STATEMENT OF ENVIRONMENTAL EFFECTS

S4.55(2) MODIFICATION APPLICATION
RESIDENTIAL FLAT BUILDING
96 NORTH STEYNE, MANLY

The proposal seeks approval to modify the existing consent pursuant to section 4.55(2) of the *EP&A Act 1979*, as shown on the submitted plans prepared by Squillace Architects, Project No. KOU1610, Issue P1, dated 30 April 2021.

Figure 1: s4.55 Ground Floor (amendment in red clouds); Squillace Issue B, August 2021

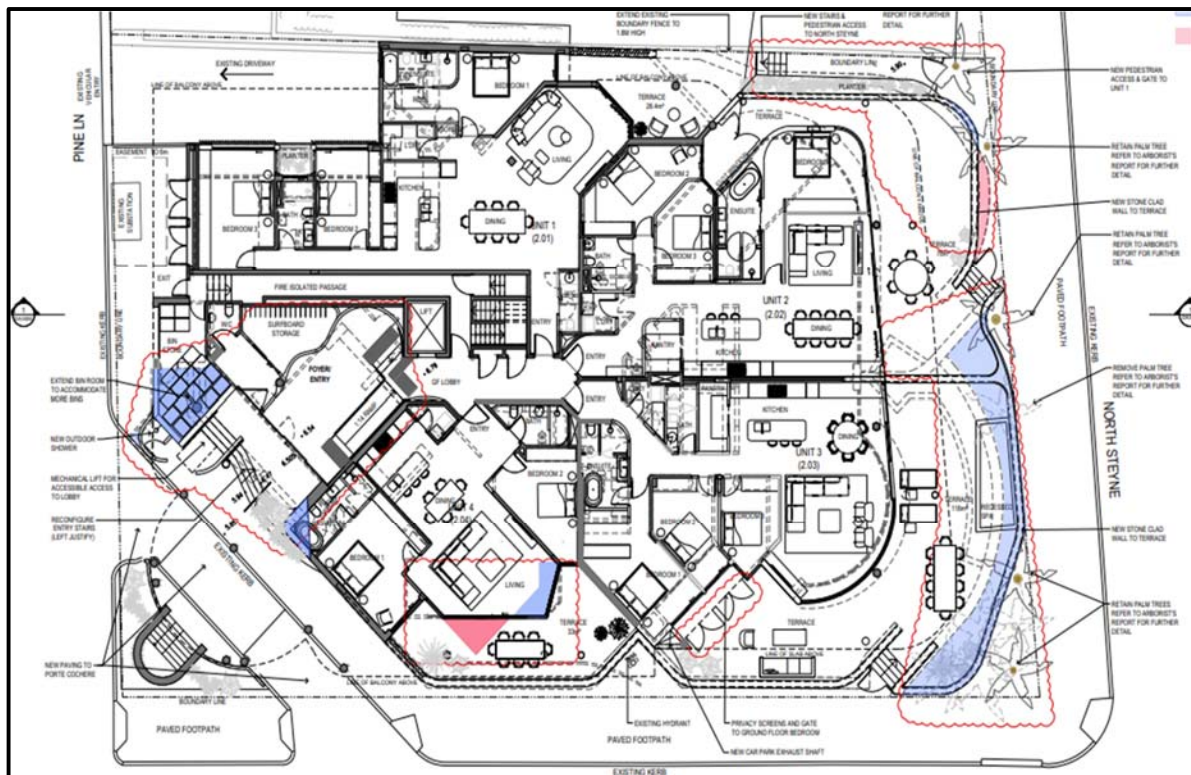
Ground Floor:

- Larger waste room.
- Reconfiguration of entry stairs.
- Additional outdoor shower at the entry.
- Additional privacy screens and gate at unit 2&3.
- Demolish existing terrace wall & replace with new wall & stone cladding
- Reconfiguration/extension of wall on the east side.
- Unit 3: new pool/spa and new glazed pool fence in terrace
- Unit 4: Extend ensuite and reconfigure glazing line

Figure 2: s4.55 Level 1 & 2; Squillace Issue B, August 2021

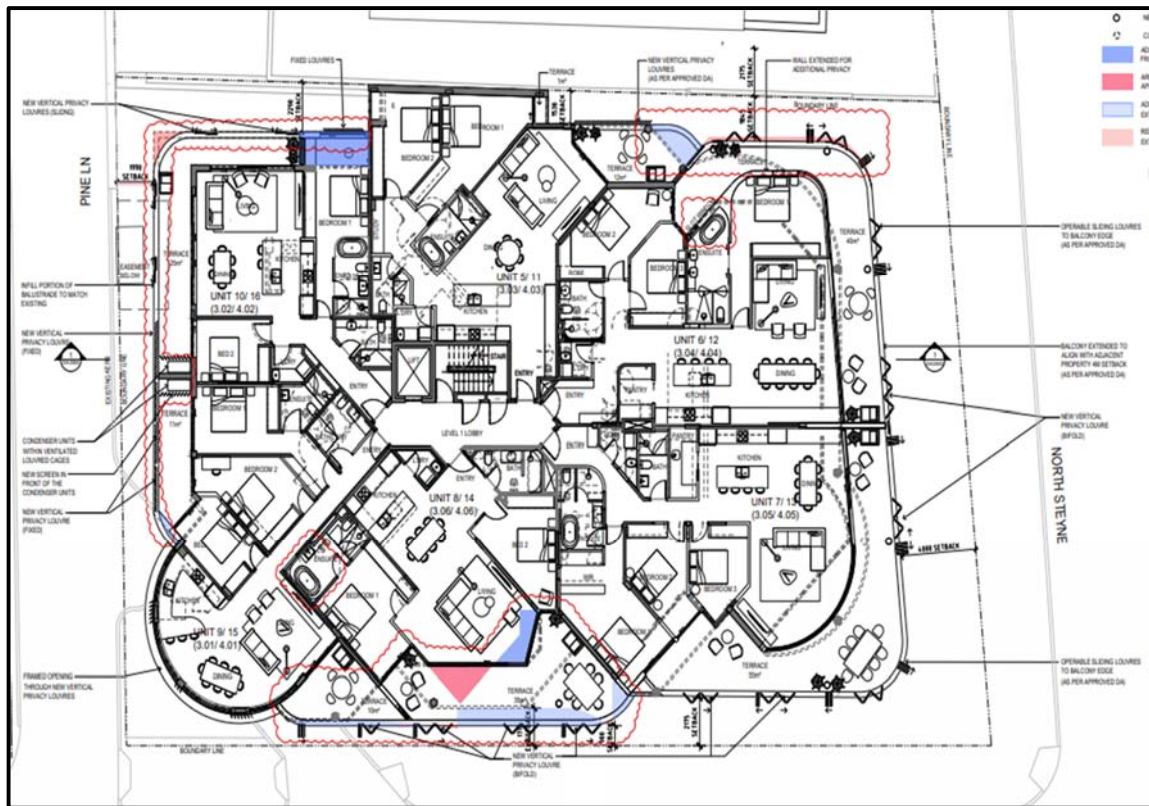
Level 1 & 2:

- Reconfigure new vertical privacy screens along the balcony in three different types, fixed, sliding, and bi fold (refer to elevation plans).
- Reshape / curved small portion of edge of the balcony to match the existing building shape.
- Reconfigure southern balcony area and privacy screens - curved edge removed and rationalised to straight edge.
- Unit 8 & 14: reconfigure external southern wall.
- Units 8, 10, 14 & 16: additional new condenser units and screen in west balcony.
- Unit 9& 15: Laundry area removed and the area added to Units 8 & 14.
- Unit 10 & 16: extension of northern external wall/windows into bedroom 1.

Figure 3: s4.55 Level 3 Floor Plan; Squillace Issue B, August 2021

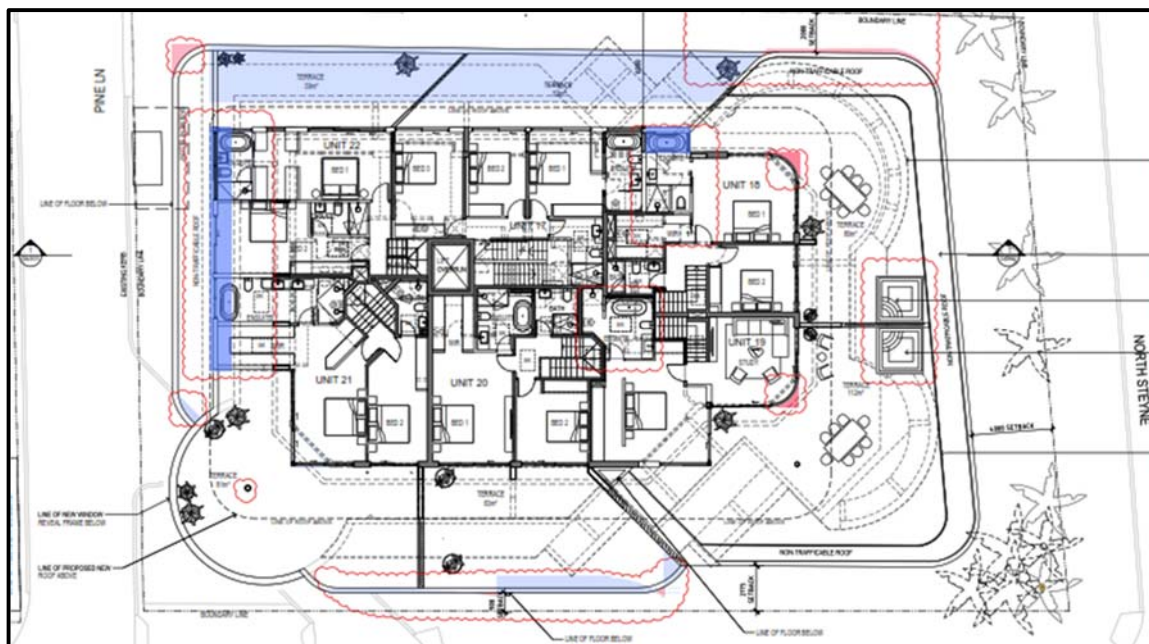
Level 3:

- Reconfigure new vertical privacy screens along the balcony in three different types, fixed, sliding, and bi fold. (refer to elevation plans).
- Reshape / curved small portion of edge of the balcony to match the existing building shape.
- Reconfigure southern balcony area and privacy screens - remove curved edge removed and rationalise to straight edge.
- Unit 20: reconfigure external southern wall.

- Units 21 & 22: additional new condenser units and screen in west balcony.

Figure 4: Level 4 Floor Plan; Squillace Issue B, August 2021

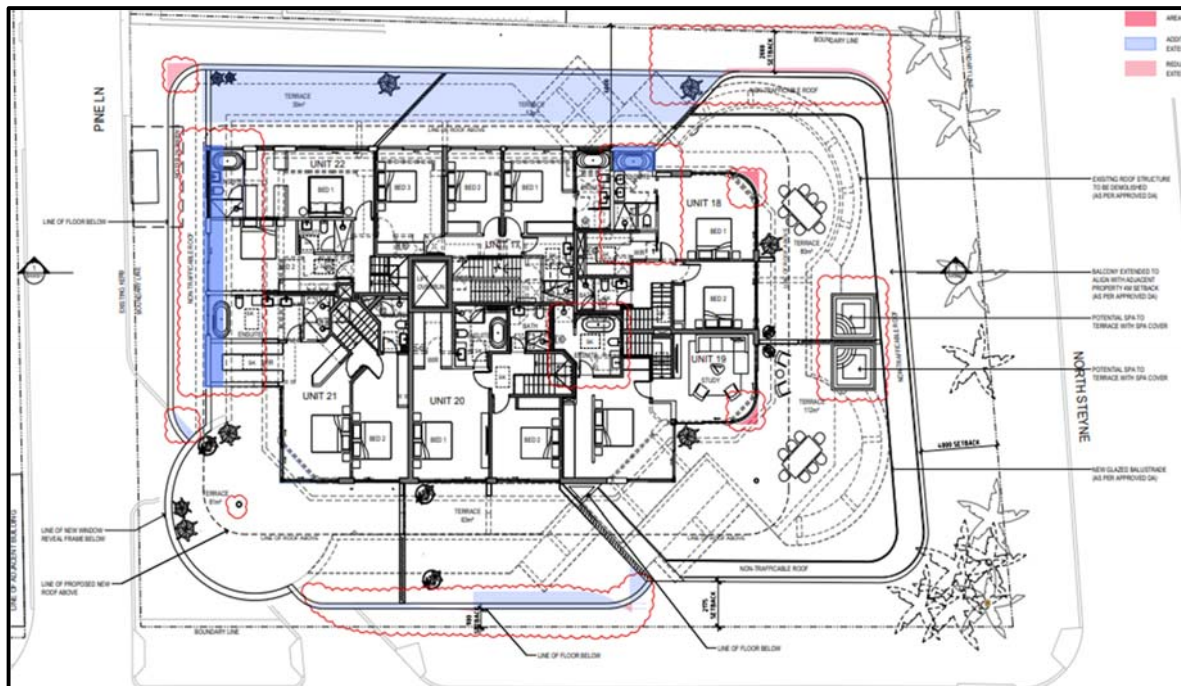
Level 4:

- Units 21 & 22: extension of external eastern wall by 1m.
- Units 18, 19: additional new spa units to balcony.
- Units 17 & 22: extend terrace area.

Figure 5: s4.55 Roof Plan; Squillace, Issue B, August 2021

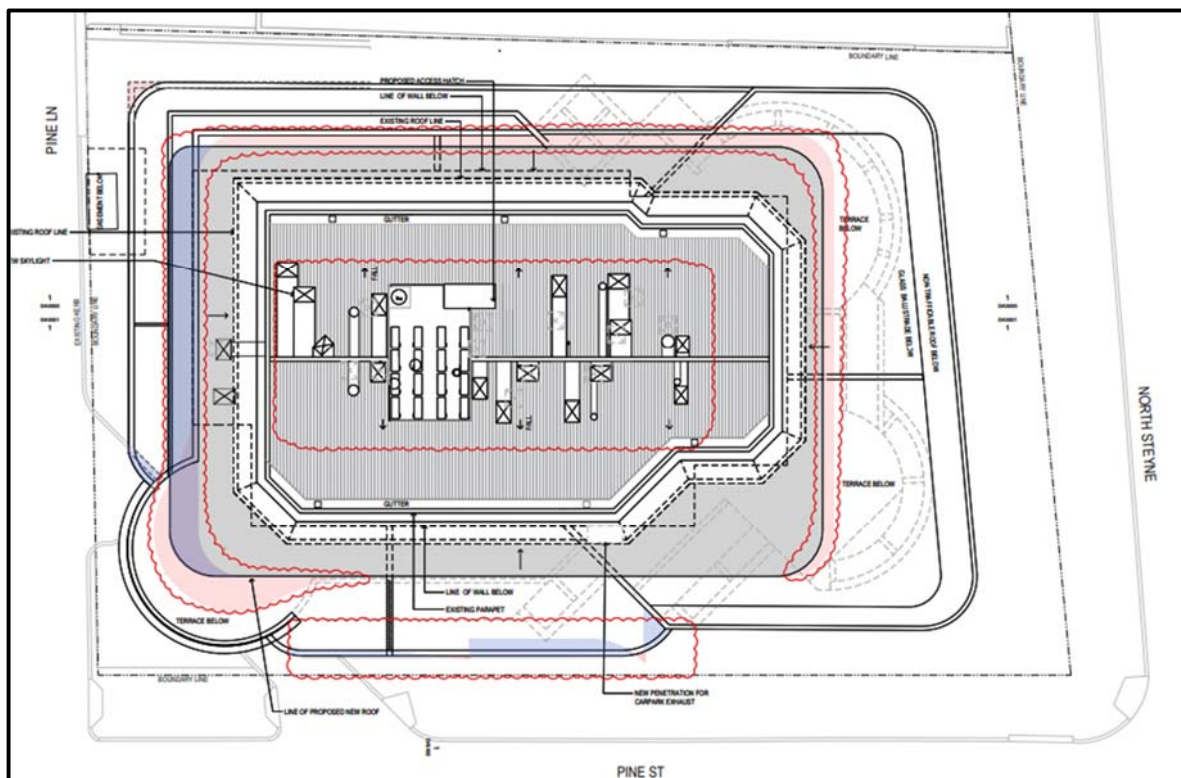
Roof:

- Reduce extent of new roof at south west corner.
- Roof overhang reduced generally.
- Relocate skylights to maximise solar access.
- New roof plant with acoustic screen.
